## SERVICE BULLETIN CHANGE NOTICE

S.B. No. A320-21-1002

TITLE: AIR CONDITIONING - PRESSURIZATION CONTROL - REPLACE CABIN PRESSURE CONTROLLERS 11HL AND 12HL

SERVICE BULLETIN  
REVISION TRANSMITTAL SHEET

**Zone 121-122 - Modification to Equipment  
Figure 2**

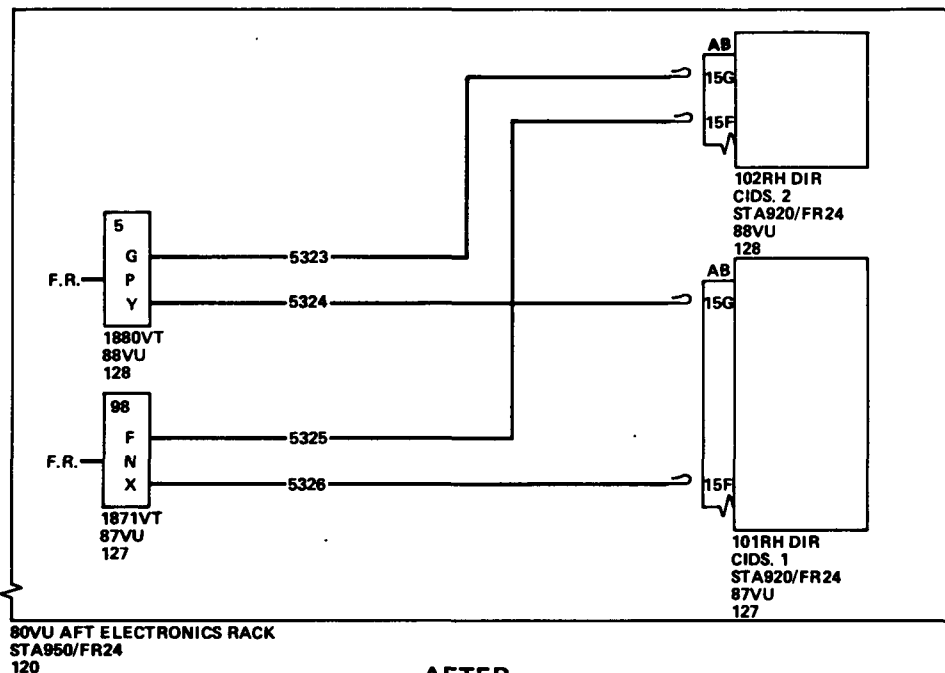
(2) Zone 121-122, installation of a new cabin pressure controller

Ref. Fig. 2

1 cabin pressure controller 12HL 9022-15702-4, item (1)

1 cabin pressure controller 11HL 9022-15702-4, item (1)

1 cabin pressure controller 11HL 9022-15702-5, item 1

1 cabin pressure controller 12HL 9022-15702-5, item 1

Zone 127-128 - Modification to Wiring in the  
Aft Electronics Rack 80VU  
Figure 3

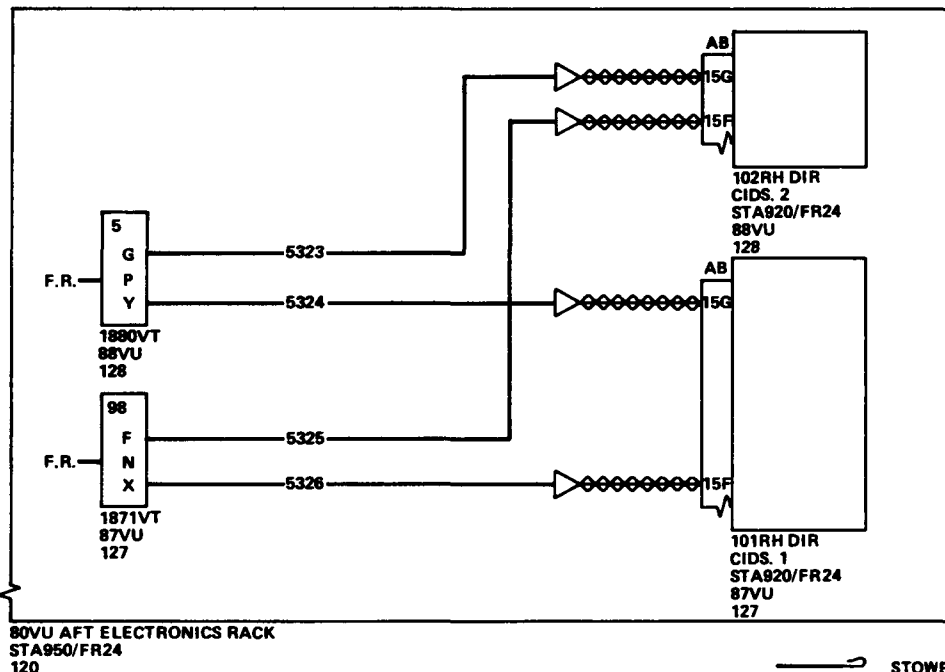
This revision is issued to add the vendor's address in para. F. and the electrical identification on CIDS 2 in Figure 3 and to update the part number of contact pin in the Hook-up Chart Figure 4 and in the Material Information para. 3.

| - Page 9/10  | Electrical Identification on CIDS. 2 in Figure 3 added.               |

Wires identified on Lines 1 thru 8 (Fig. 4).
